SUBJECT: Forwards response to NRC questions re effects of emergency power overfrequency on Units 1, 2 & 3.

Subject: Oconee Nuclear Station
Docket Nos. 50-269, -270, -287
Response to NRC questions on Technical Specification 4.6
Revision

REQUEST FOR INFORMATION
OCONEE NUCLEAR STATION - UNITS 1, 2, AND 3
KEOWEE OVERSPEED CONDITION FOLLOWING A LOAD REJECTION

1 Unit 88 Mw Keowee Operating Chart

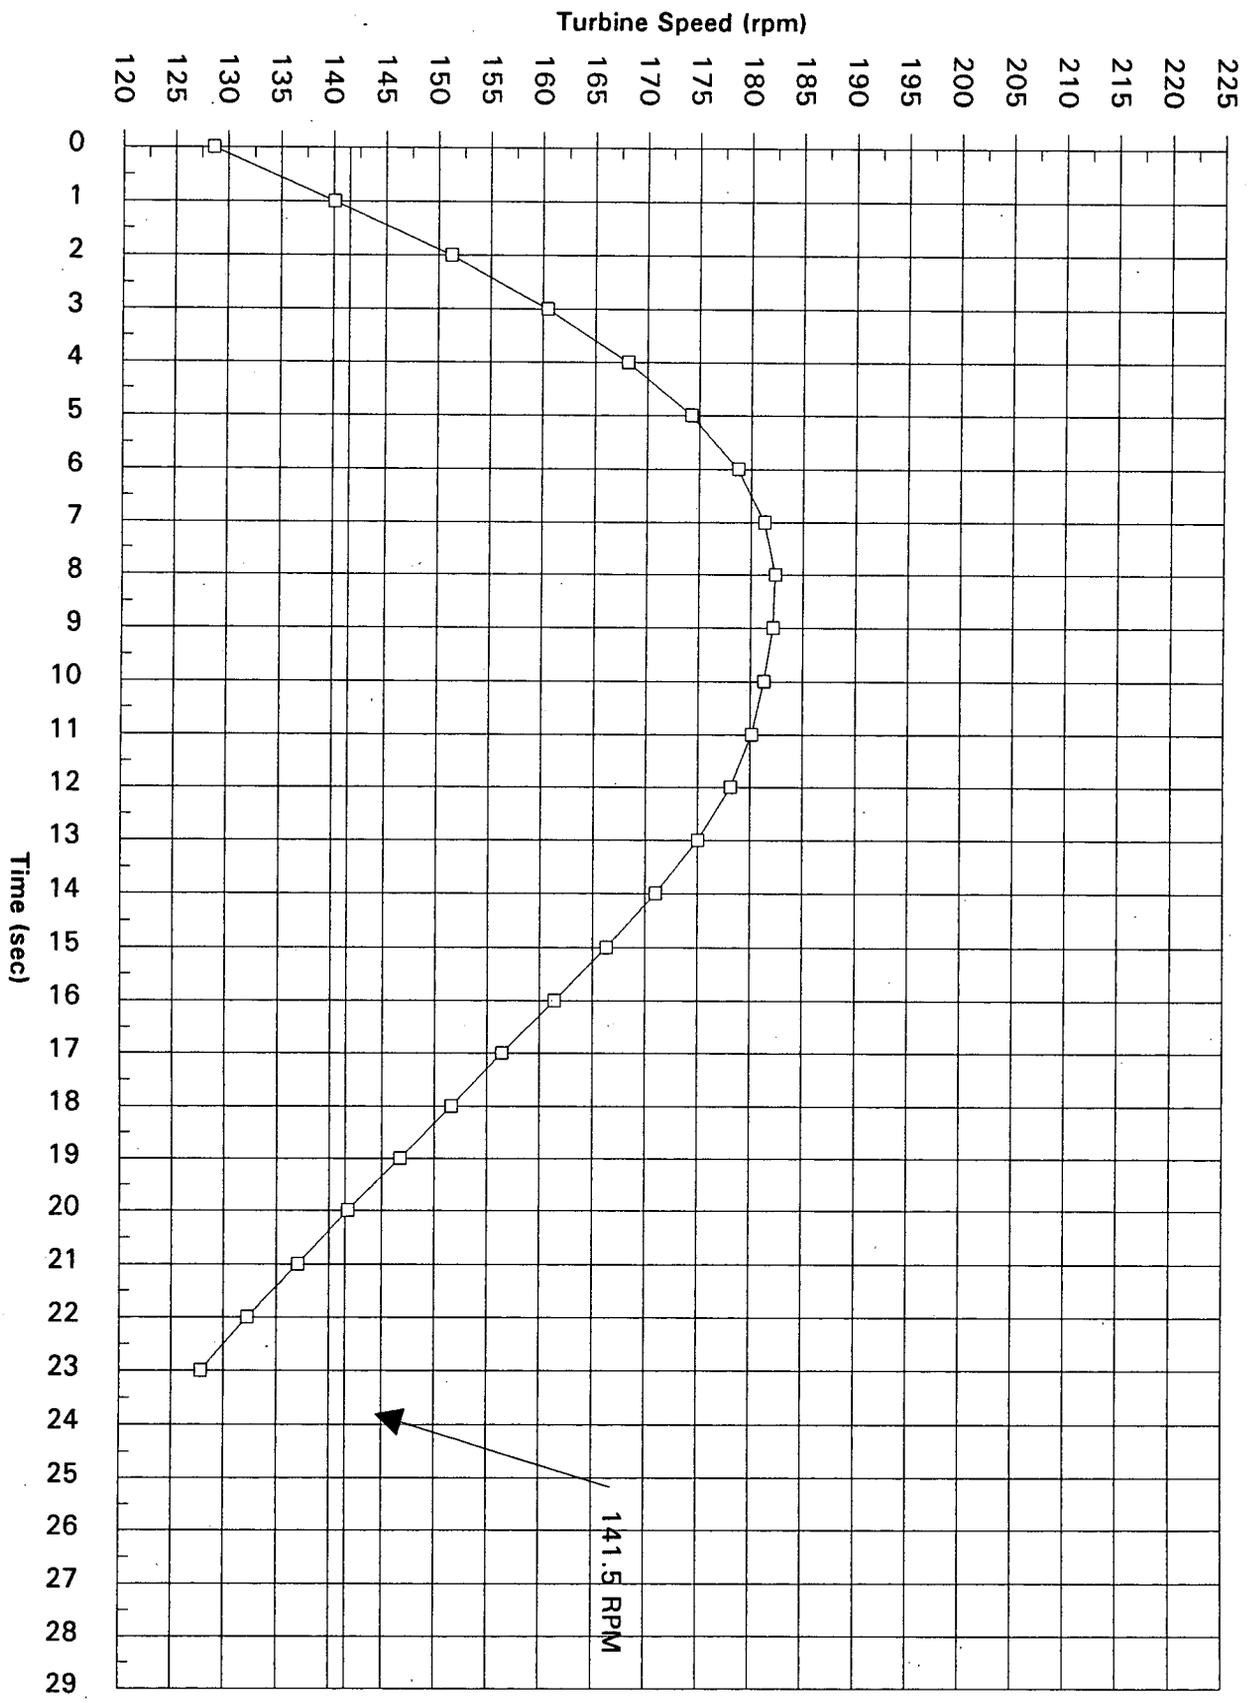
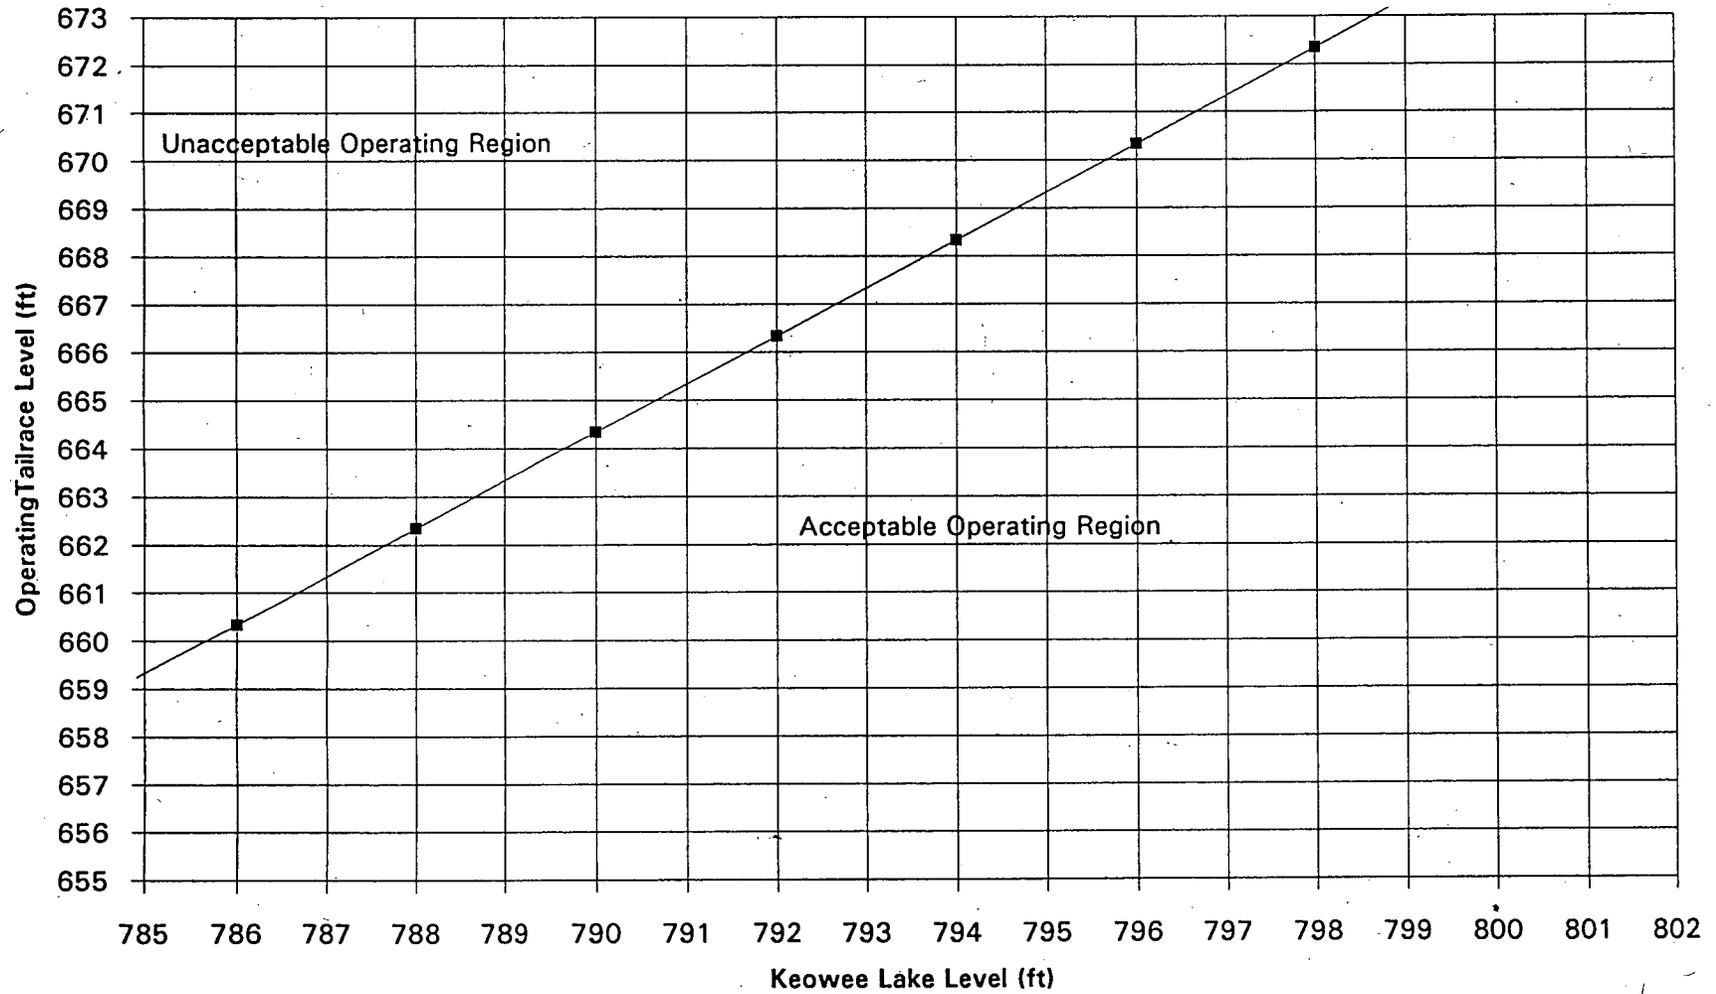
Please provide frequency and voltage plots vs. time for the power supplied by the Keowee units during a postulated overspeed/overfrequency scenario and any sensitivity studies conducted to show how frequency and voltage change with different lake levels or different power output levels of the Keowee units. Also, please provide any calculations performed to determine maximum and minimum lake levels for Keowee normal mode operations and the maximum Keowee power output levels permitted at these lake levels to ensure the time requirements contained in applicable accident analyses are met.

If a plot of tailwater elevation versus headwater elevation is made, a line of constant gross head (125.6 feet) can be drawn (Attachment 4). If the unit is operated with a gross head greater than 125.6 feet (below the line), then the unit will respond with a less severe load rejection and will be below 110% speed in less than 22 seconds. If the unit is operated with a smaller gross head, then the load rejection will be more severe. Therefore, the region below and to the right of the line is identified as the acceptable operating region.

Curves like Attachment 4 were generated for each anticipated power and operating unit combination by calculation KC UNIT 1-2-0106. The Operating Restrictions enclosure in the Keowee Modes of Operation procedure will be revised to include this information.
